March 7, 2025

**SUBJECT: ADDENDUM TO THE FINAL MASTER ENVIRONMENTAL IMPACT
REPORT FOR MASTER PLAN OF RECREATION USES FOR CENTRAL
PARK, CITY OF HUNTINGTON BEACH, CALIFORNIA – SYMPHONY OF
THE FLOWERS PROJECT, SCH NO. 97091007, ORANGE COUNTY, CA**

ATTACHMENT C: BALD EAGLE OBSERVATION AREA, COMPILED BY MELISSA BORDE, CDFW

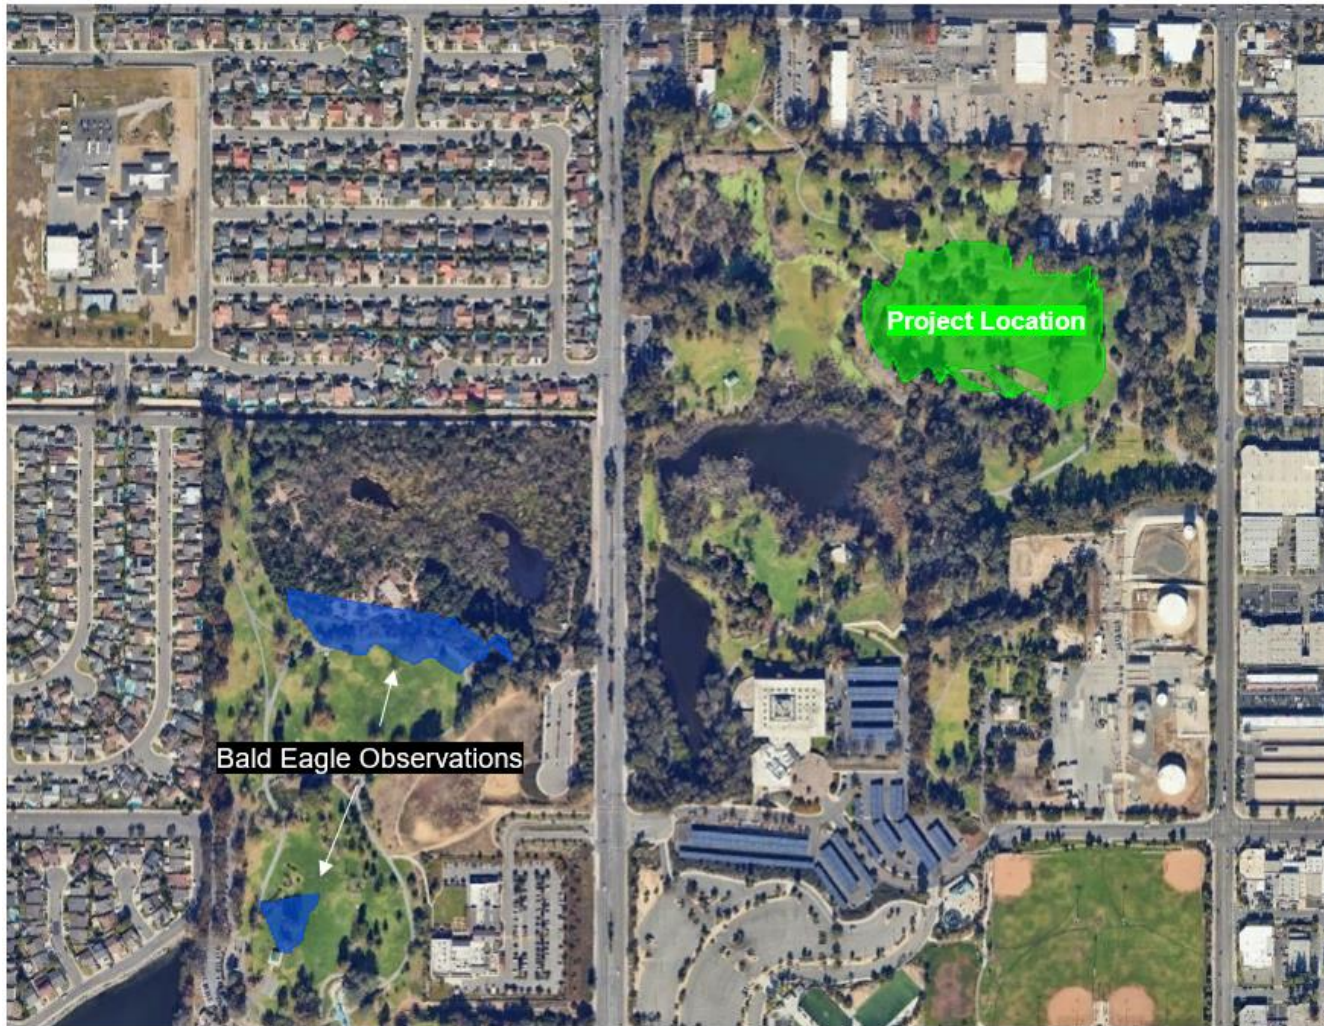
COMMENT # 3: Bald Eagle. Bald eagle was not identified in the Addendum; however, there have been recent citizen observations of two bald eagles utilizing habitat in the adjacent Central Park West, approximately ¼ mile from the Project site (Attachment C). The most recent observation on iNaturalist was in February 2025. Bald eagle is a CESA endangered and FP species, and protected under the Bald and Golden Eagle Protection Act (BGEPA; 16 U.S.C. § 668-668d) and the Migratory Bird Treaty Act (MBTA; 16 U.S.C. §§ 703-712). The BGEPA prohibits anyone without a permit from taking either species, including their parts, nests, or eggs. U.S. Fish and Wildlife Service recommends buffer zones of no disturbance, which vary depending on the type of Project or disturbance (USFWS, 2017). Non-motorized recreation and human entry (e.g. hiking, camping, fishing, hunting, birdwatching, kayaking, and canoeing) require a 330-foot buffer, while blasting and other loud, intermittent noises require a buffer of ½ mile. Though no nests have been reported, the biological reconnaissance survey was conducted in October, outside of nesting season. Pre-construction surveys should include surveying for bald eagle nests within the Project area and surrounding habitat. CDFW recommends discussing bald eagle in the final Project CEQA document, and incorporating the below enforceable mitigation measure:

Mitigation Measure #2: Bald Eagle. To ensure avoidance of bald eagle impacts, if a bald eagle or other raptor nest is detected during nesting bird surveys or incidentally observed on or near the Project site, the City shall coordinate with the Wildlife Agencies to determine appropriate buffer distances for Project activities. Additional avoidance measures will be implemented in coordination with the Wildlife

ATTACHMENT D: ADDENDUM FIGURE 4 – WATER BASIN

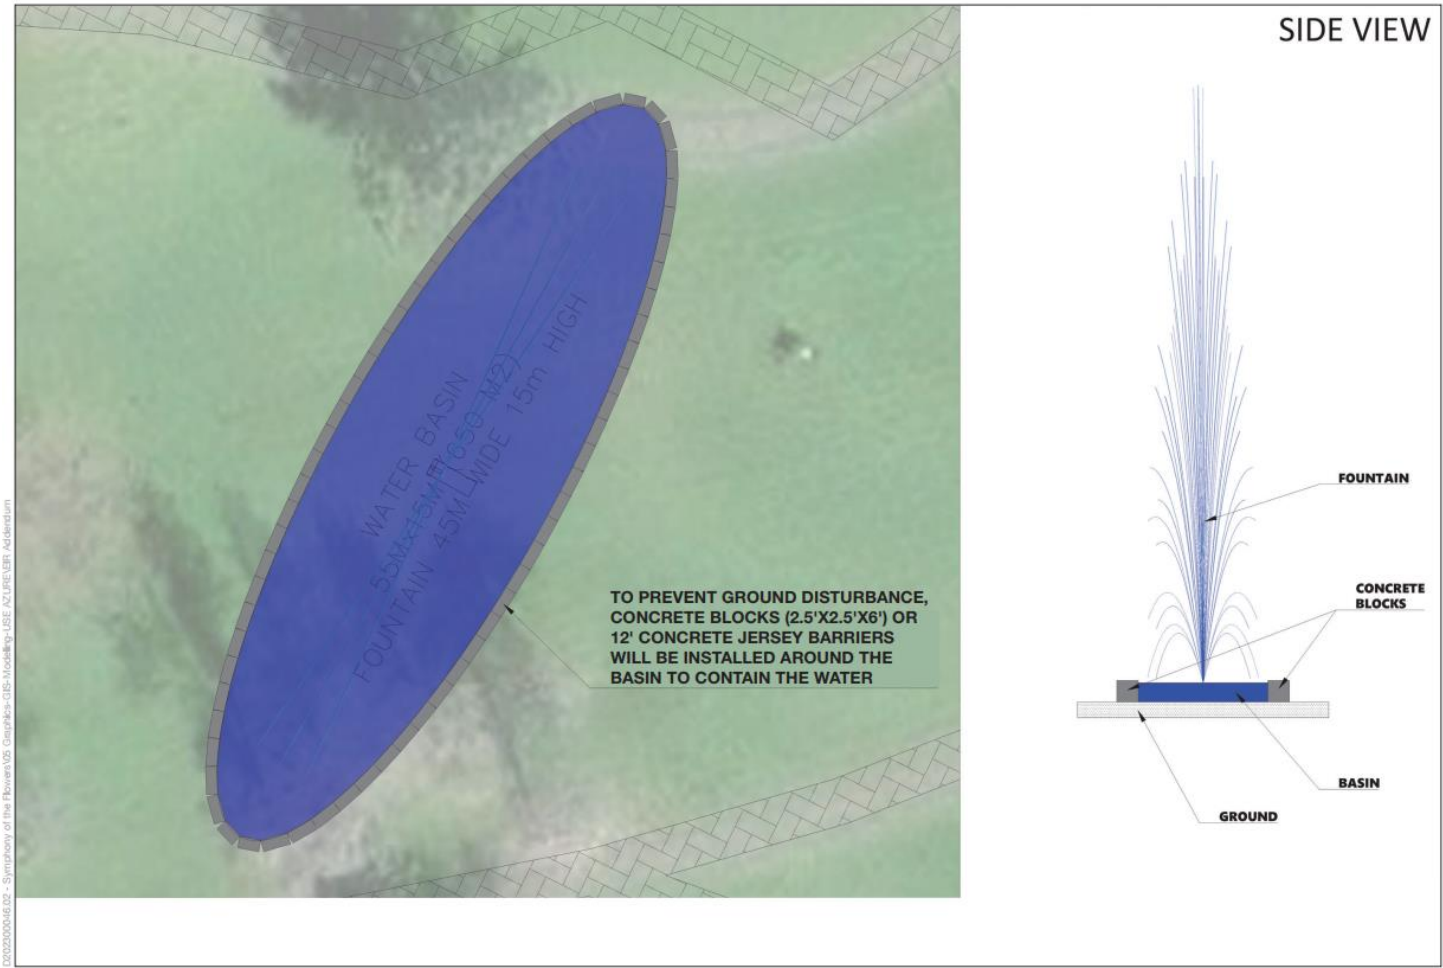
COMMENT # 8: Water Basin. The Addendum contains minimal analysis of environmental impacts from installation of a 180-foot-long and 50-foot-wide water basin. The basin includes an approximately 150-foot-wide by 50-foot-tall fountain in the middle, onto which light will be projected using a projection screen (Attachment D). The Proponent will truck in water to fill the basin. The Addendum indicates that, to prevent ground disturbance, concrete blocks or jersey barriers will be installed around the basin to contain the water. Pumps will be used to prevent stagnant water and create a water screen effect. The Addendum indicates that the water will be treated with natural algaecide that is safe for wildlife and approved by the City. There is no further analysis of how wildlife will be affected.

CDFW is concerned that installation of a large water feature may have potentially significant direct and indirect impacts on wildlife, which were not analyzed in the Addendum. The temporary water basin is likely to attract wildlife, particularly birds such as ospreys, herons, waterfowl, and bald eagles, which rely on visual cues to identify nesting and foraging habitat. Projection lighting and water reflections may disorient night-migrating birds, leading to collision fatalities and increased risk of predation (Longcore & Rich, 2004). Small mammals and reptiles may become entrapped in the water basin and drown. The Addendum does not describe any mitigation measures to prevent mammal and reptile mortality, such as wildlife escape ramps. The Addendum also does not disclose if the water will continuously circulate with the pumps- mosquitos can rapidly colonize in standing water, potentially increasing vector-borne disease transmission to humans and wildlife.

It is also not disclosed in the Addendum how the water will be disposed of upon completion of the Project. The Addendum indicates that the water will be treated with 'natural algaecides,' but does not detail which treatments will be used or analyze the potential toxicity to wildlife. If treated water is discharged on site, runoff into Talbert Lake could introduce pollutants or harmful algal blooms, which would disrupt the aquatic community and the species that utilize that habitat. CDFW recommends incorporating the following into the Project's final CEQA document:

Recommendation #3: Water Basin. The CEQA document shall provide a thorough analysis of the biological impacts relating to the proposed water feature. The document should disclose: the volume of water required, specific water quality treatments/chemicals that will be used including concentration and risks to wildlife, monitoring criteria and frequency, who is responsible for ensuring water quality, water feature (e.g. a 50' tall fountain and projection lighting) effects on wildlife including birds, amphibians, mammals, and pollinators, projection lighting effects on wildlife, fountain/pump operational hours, and a mosquito abatement plan.

Mitigation Measure #6: Water Basin. The Project's water feature shall only be installed if additional studies show that operation will not disrupt wildlife, including birds, amphibians, mammals, and pollinators. Wildlife escape ramps shall be installed in multiple locations around the interior perimeter, to provide an exit point if mammals, amphibians, or pollinators shall become trapped. Any algicides that are used shall be determined to be wildlife friendly, used in the correct concentrations, and approved by the Wildlife Agencies. The qualified biological monitor will ensure that water quality is maintained throughout the duration of the Project and that no animals are trapped. Any animal mortalities shall be immediately reported to the Wildlife Agencies. Upon completion of the Project, water from the temporary water basin shall be pumped back into trucks and properly disposed of off-site, away from any habitat.

ATTACHMENT E: ADDENDUM FIGURE 5A - SPEAKER LOCATION

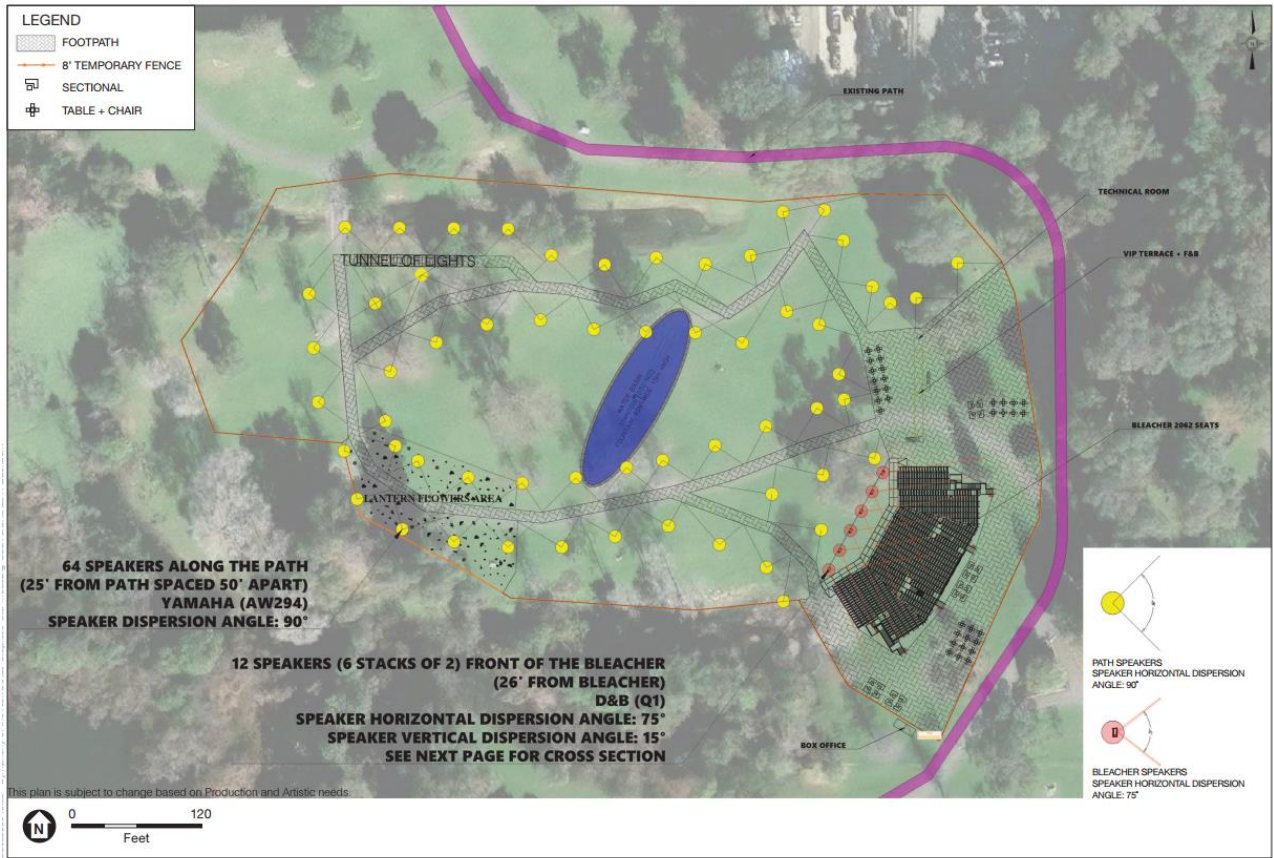
COMMENT # 9: Noise Analysis. The Addendum indicates that the Project will install 76 speakers, including 12 speakers directed at the temporary bleachers, as well as 64 speakers dispersed along the pathways. The 12 speakers are positioned to play music during the show, and the 64 speakers along the paths will simultaneously play ambient music. Biological resources near the Project site include arroyo willow thickets, which may provide habitat for vireo and other sensitive birds within the BSA, approximately 100 feet southwest of the Project site, as well as the eucalyptus groves, which are documented roosting habitat for overwintering monarch. The Addendum incorporated a noise analysis for the Project (Attachment E), indicating that noise levels at the biological resource areas near the Project Site would approach and potentially exceed 60 dBA Leq. However, the Addendum indicates that biological impacts will be below significant levels with incorporation of the Project Features discussed above. Potential sources of noise include construction and disassembly of the Project, as well as operation of the Project and music funneling through 76 speakers. The Addendum anticipates that crowds will average 900 people per show, with seating for up to 1,800 people; however, noise analysis is limited to speaker sounds, and does not incorporate crowd noise, or predict intense bursts of noise and vibration, such as from cheering and clapping. CDFW is concerned that vibration and noise generated from the audience may disturb

Recommendation #4: Noise Analysis. CDFW recommends that the final Project CEQA document incorporate a noise analysis which includes noise generated from up to 1,800 attendees, if the venue reaches capacity. The analysis should include an analysis of ambient noise from conversations, as well as noise and vibration analysis from cheering or clapping. The noise model should be analyzed in relation to nearby habitat and demonstrate how sensitive species impacts will be avoided.

Figure 8
Noise Model

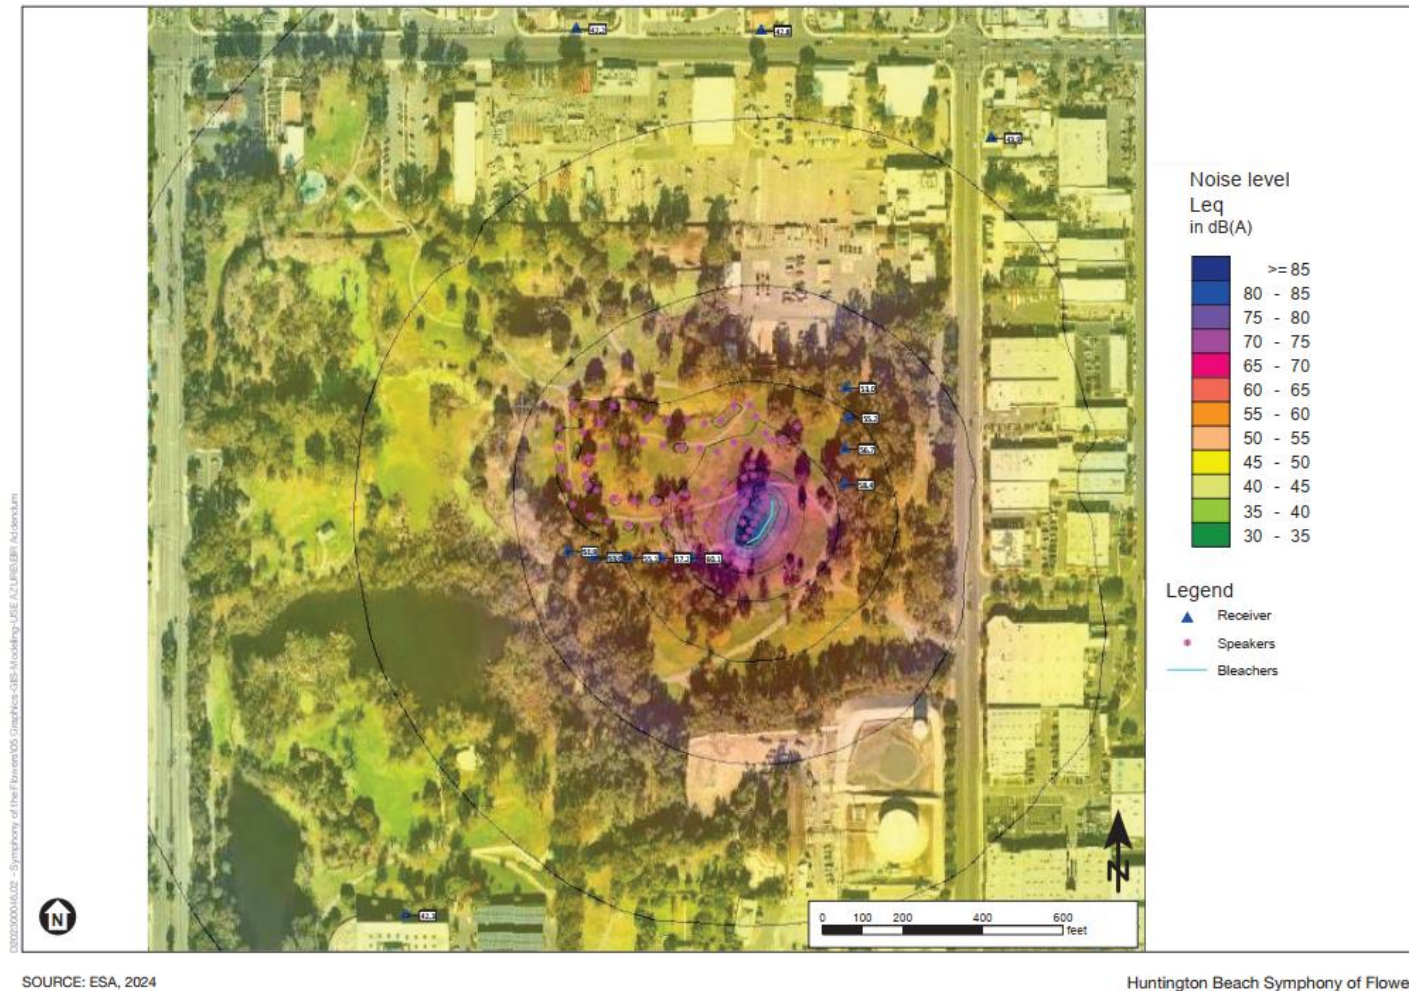
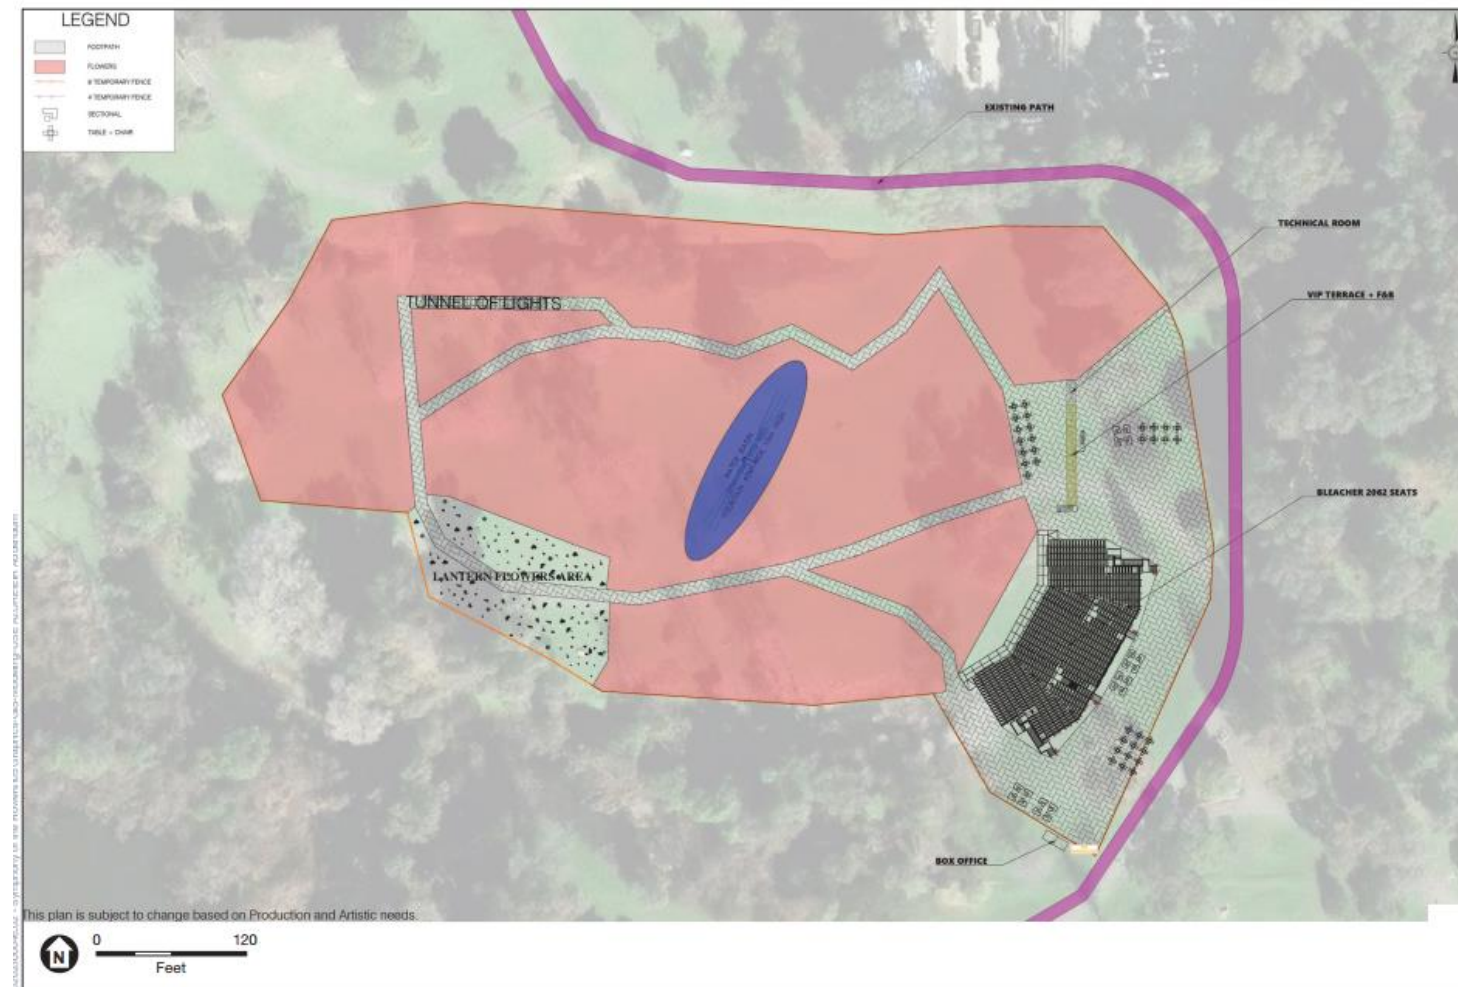
The Site Plan (Attachment H) illustrates that the bleachers will be immediately adjacent to one of the monarch overwintering locations, with the stacks of 12 speakers pointed toward the habitat. The noise model (Attachment F) models noise levels around 58 dB(A) at the edge of the eucalyptus habitat. However, the Project anticipates crowds averaging 900 people per show, but does not include analysis of noise output from a large crowd gathering, or disruptive noise like clapping and cheering (discussed further in Comment #9). Project lighting near the eucalyptus groves may also adversely impact overwintering monarchs; lights that are proposed over the bleachers, path, and VIP terrace are immediately adjacent to the eastern eucalyptus grove. The Addendum includes a provision for potential noise barriers or visual barriers, but does not include any success criteria or parameters, or plans to redesign the site layout if it is determined that impacts are unavoidable.
